Inspectors Second Written Questions

**Appendix A- Impact on Cranford Park- Comments issued at Deadline IV**

**SHEET 1: Cranford Park Conservation Area and M4**  
Date of all pictures: 13/11/2015

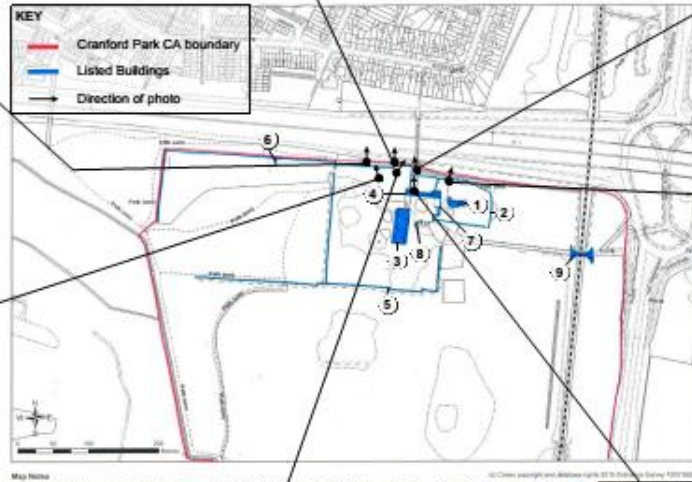
<p><b>4. Environment;</b></p> <p><b>4.2 Landscape and Visual effects</b></p>	
<p>4.2.1                  From our visit to Cranford Park and its listed buildings EV-006 , it was clear that the M4 currently has a significantly harmful effect on the amenities of the Park both in terms of noise and visual amenity. The listed buildings are on the ‘at risk register’ and the local community are working to conserve the buildings and to find new uses for them. The Park provides a valuable open space amenity in an otherwise urban area. The proposal to bring traffic closer to the Park and the listed buildings through all lane running (ALR), together with the positioning of new gantries would be likely to increase visual impact. Furthermore, whether or not ambient noise levels were reduced, the source of the noise would become more evident.                  What provisions can be made for enhancements to the visual and aural environment of the Park in terms of boundary treatment to the M4 such as higher fencing to provide visual and acoustic mitigation, and increased planting?</p>	<p>Heritage comments: the council has submitted comments with regard to the impact on the heritage assets of the site, these are re-provided at Appendix A of this response. The council also await submission of the requested Cranford Park survey which was requested by the ExA and is due for submission in Jan 2016.</p> <p>Landscaping comments: Acoustic fencing should be provided to the north of the east-bound slip road and to the south of the west-bound slip road to enhance the visual and aural environment for those enjoying the amenities of the Park and listed buildings.</p> <p>The overall height of the fence should be determined by the need to both screen the views and to be effective acoustically.</p> <p>A solid acoustic fence, such as timber or coir, could be erected to sufficient height to block out eye-level views (from the Park) to the source of the noise on the motorway, including high-sided vehicles.</p> <p>With regard to blocking the views, the height of the solid fence should take into account local topography and changes of level. For example, if the ground level of the Park is lower than that of the motorway, a lower fence height may be effective visually. Conversely, if the adjacent land level is higher than the motorway, a greater fence height will be required to screen views of vehicles and the source of the noise.</p>

<p>One downside of installing solid acoustic barriers fencing is that they are visually intrusive in the landscape and may block out desirable longer distance views and the skyline, above the motorway traffic.</p> <p>If the fence height needs to be higher for the purpose of acoustic mitigation than that required to screen the source of the noise, transparent acoustic panels should be used at a higher level - as used extensively in Europe.</p> <p>Where possible, off-site planting (using mixed native woodland species) should be planted on the Park side of the fence so that the impact of the fence itself is 'lost' behind a screen of vegetation. The planting mix is likely to be predominantly deciduous (only in leaf for approximately 6 months of the year) but should include some evergreen species. It should be noted that any new planting will take some years to achieve the desired height and density to form an effective visual screen. (see comments in final box relating to off-site planting).</p>

**SHEET 2: Harlington Conservation Area and M4**  
Date of all pictures: 13/11/2015

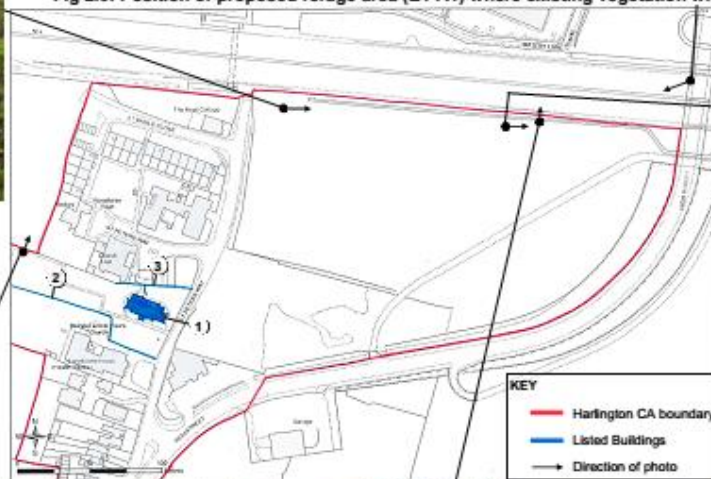
<p>4.2.2 Having regard to the positioning of new gantries and the emergency refuge areas (ERA) in proximity to Harlington Village Conservation Area and the Church of St Peter and St Paul, what additional shrub and tree planting can be provided to mitigate the introduction of the gantries and the impact of bringing traffic closer to the heritage assets?</p>	<p>The nearest proposed gantries either side of the St Peter's subway include G1-03, G1-07 and G-11 (south side / west-bound) and G1-08 and G1-09 (north side, east-bound). Due to the height and scale of the gantries, they will be impossible to screen from view from all viewpoints outside the motorway corridor. To some extent views may be filtered from some vantage points by existing (retained) vegetation and built structures.</p> <p>Gantry G1-07 lies due north of the church and will be highly visible. There is very limited space behind the gantry, within the motorway corridor, to provide adequate screening. At a lower level fencing along</p>

<p>The Council has provided additional views of the gantry positions (G1-07 and G1-08) in attached Sheet 2. These are views adjacent to the Harlington Village Conservation Area boundary and as noted in the Council's Local Impact Report. Highways England's most recent consideration of the impact of the gantries and refuge E1-A1 on views from within the extended conservation (figs 2.0- 2.3) is not supported by the Council and the view from the rear the Church of St Peter and St Paul (fig 2.4) has not been addressed by them. With regards to these locations, the Council is of the view that the impact of the works is such that it would wish to see additional shrub and tree planting provided, even if this is off site, as the proposed replacement grass seeding would do little to screen views of the new structures and areas of hard surfacing- the latter to be created directly on the boundary of the conservation area.</p> <p>Please see Appendix B for Sheet no.1 and Sheet no.2 referred to in this section.</p>

<p>the boundary would reduce some of the visual impact. Planting around / behind the gantry would help to filter views over time.</p> <p>The filtering of views of G1-09 viewed from Harlington Village to the south could be enhanced by additional woodland planting on Council-owned land directly opposite, between St Peter's Close and the motorway.</p> <p>In addition to this, the long distance oblique views could be enhanced by providing longer stretches of woodland planting between the carriageway and the motorway boundary, for example between G1-07 and G1-11. - If this is not feasible, off-site planting to the south of the motorway boundary should be considered.</p> <p>Lower level views and the blocking of views of the source of the traffic noise could best be improved by installing acoustic fencing.</p> <p>The closest ERA's include E1-A1 (south side, west-bound) and E1-B1 (north side, east-bound). These features are relatively low-lying and could be fenced close to the edge of the ERA, with mixed woodland planting between the fence and the motorway boundary (for longer term screening).</p> <p>The approach to the pedestrian subway at the north end of St Peters Way provides uninterrupted exposure to the motorway traffic and source of traffic noise. This is a problem shared with St Dunstan's and several other pedestrian underpasses. These gaps in the fencing would benefit from the installation of acoustic barriers. The barriers could be staggered in such a way as to close the gap so that the view is blocked while continuing to provide pedestrian access.</p>
